Subject: PEX2018/0009 - Submission re amended planning proposal at 1294-1300 Pittwater Rd and 2-4 Albert St Narrabeen

Submission re Planning Proposal 1294-1300 Pittwater Road and 2-4 Albert Street Narrabeen 2101

FIGURE 3.1 PROHIBITED LOCATIONS OF ACCESS DRIVEWAYS

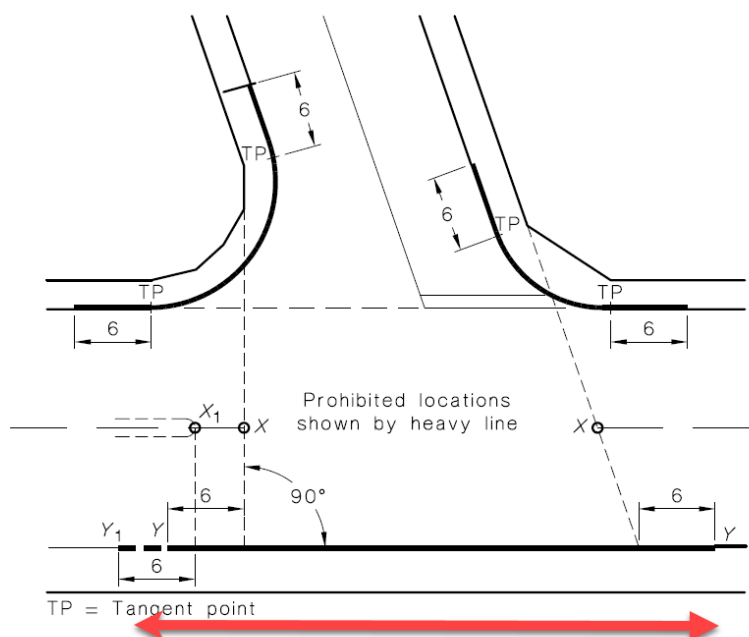
Secondly, the repositioned access location shown in Figure 3.2 of the Traffic Report is clearly within the PROHIBITED LOCATIONS FOR ACCESS DRIVEWAYS from Figure 3.1 of Australian Standard 2890.1:2004 (see below).

This is blatantly in contradiction with the statement in the Traffic Report that the basement carparking (which must obviously include the driveway) would be provided in accordance with AS2890.1:2004. While the basement may comply, the location of the entrance does not and cannot be made to comply without relocating it to Pittwater Road. Further east along Albert Street is obviously complicated with the narrow width of Albert Street. Clearly Albert Street is not an appropriate solution in any location.

Reconsidering the evaluation criteria in Section 4.2 of the Traffic Report, the appropriate conclusion is obviously that the access driveway should be to Pittwater Road. The alleged impact on B-Line bus is spurious as the B-lines are very often moving into the other traffic lanes as they leave the bus stops (i.e. they are moving around the other buses stopped in front of them). Driveway access to the development on Pittwater Road would also have the advantage of the pedestrian crossings to the north providing a regular stop in the traffic flow to provide entry and exit, particularly as there will be increased numbers of pedestrians using the crossings to access the new development.
